# Access Compliance Report

## Public Rights-of-Way

### (Curb Ramps)

Intersection ID: 50635	Main Street: RED_WATER_RD	Cross Street: BLUE_BLOSSOM_RD	Location: NW
ADA ID: ECA5F3741E5F	Ramp Type: Perp	Initial Pass/Fail: Fail	Overall Compliance: No
		Severity Score: 22.5

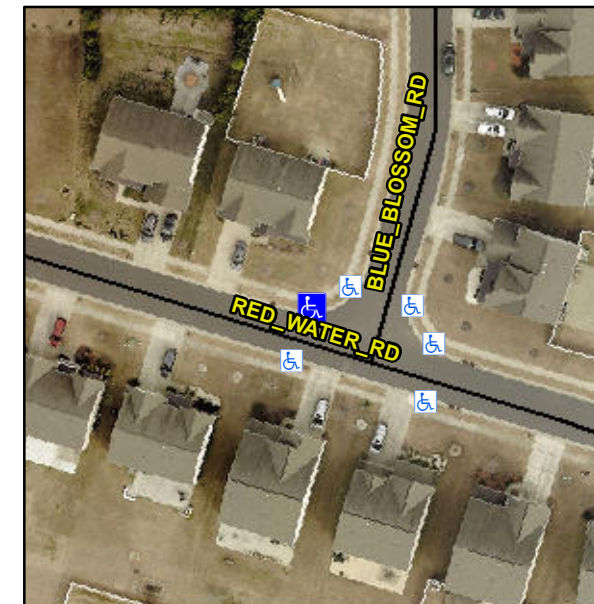
**Not Found, R304.5.1, R304.2.2, R304.5.3**

Compliance	Description	Data	Compliance	Description	Data
N/A	Ramp Length (in)	45.5	No	Ramp Slope (%)	10.2
No	Ramp Width (in)	47.0	No	Ramp XSlope (%)	2.9
N/A	Flare Type LT	N/A	N/A	Flare Type RT	N/A
N/A	Flare Slope LT (%)	N/A	N/A	Flare Slope RT (%)	N/A
N/A	Flare Traversable LT?	N/A	N/A	Flare Traversable RT?	N/A
N/A	Landing Length (in)	N/A	N/A	DWS Provided?	N/A
N/A	Landing Width (in)	N/A	N/A	DWS Contrast?	N/A
N/A	Landing Slope (%)	N/A	N/A	DWS Length (in)	N/A
N/A	Landing X Slope (%)	N/A	N/A	DWS Full Width?	N/A
N/A	Landing Curb? (Y/N)	N/A	N/A	DWS Offset (in)	N/A
N/A	Shared Landing?	N/A			
N/A	Gutter Ponding?	N/A	N/A	Gutter Slope (%)	N/A
N/A	Gutter Lip Ht (in)	N/A	N/A	Gutter X Slope (%)	N/A
N/A	Painted X Walk1?	No	N/A	Painted X Walk2?	N/A
	X Walk 1 Direction	To SW		X Walk 2 Direction	N/A
N/A	X Walk 1 Width (in)	N/A	N/A	X Walk 2 Width (in)	N/A
	X Walk 1 Slope (%)	2.0		X Walk 2 Slope (%)	N/A
	X Walk 1 X Slope (%)	2.7		X Walk 2 X Slope (%)	N/A

**Remove & Replace Entire Ramp.**
